# Access Compliance Report

## Public Rights-of-Way

Intersection ID: N/A	Main Street: BISCAY_DR	Cross Street: PROVIDENCE_RD	Location: SW
ADA ID: F48B4338B6E7	Ramp Type: Directional1	Initial Pass/Fail: Fail	Overall Compliance: No
		Severity Score: 12.5

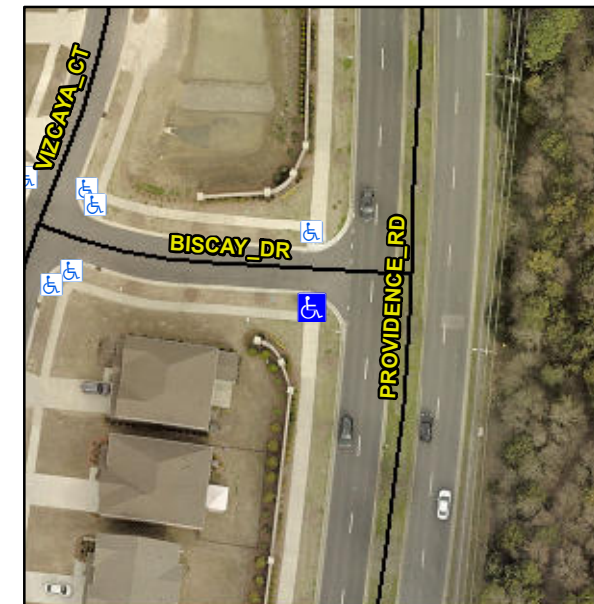
**CURB LIP 1.0"**

**R304.2.2**

Compliance	Description	Data	Compliance	Description	Data
N/A	Ramp Length (in)	75.0	N/A	Grade Break?	N/A
Yes	Ramp Width (in)	95.0	N/A	Grade Break Slope (%)	0.0
No	Ramp Slope (%)	11.2	N/A	Grade Break XSlope (%)	0.0
Yes	Ramp XSlope (%)	0.7			
N/A	Flare Type LT	N/A	N/A	Flare Type RT	N/A
N/A	Flare Slope LT (%)	N/A	N/A	Flare Slope RT (%)	0.0
N/A	Flare Traversable LT?	N/A	N/A	Flare Traversable RT?	N/A
N/A	Landing Length (in)	0.0	N/A	DWS Provided?	N/A
N/A	Landing Width (in)	0.0	N/A	DWS Contrast?	N/A
N/A	Landing Slope (%)	0.0	N/A	DWS Length (in)	N/A
N/A	Landing X Slope (%)	0.0	N/A	DWS Full Width?	N/A
N/A	Landing Curb? (Y/N)	N/A	N/A	DWS Offset LT (in)	N/A
N/A	Shared Landing?	N/A	N/A	DWS Offset RT (in)	N/A
N/A	Gutter Ponding?	0.0	N/A	Gutter Slope (%)	N/A
N/A	Gutter Lip Ht (in)	0.0	N/A	Gutter X Slope (%)	N/A
N/A	Painted X Walk1?	No		Road Slope (%)	2.6
	X Walk 1 Direction	To N		Road X Slope (%)	1.4
	X Walk 1 Width (in)	N/A		Clear Space?	N/A

**Remove & Replace Entire Ramp.**
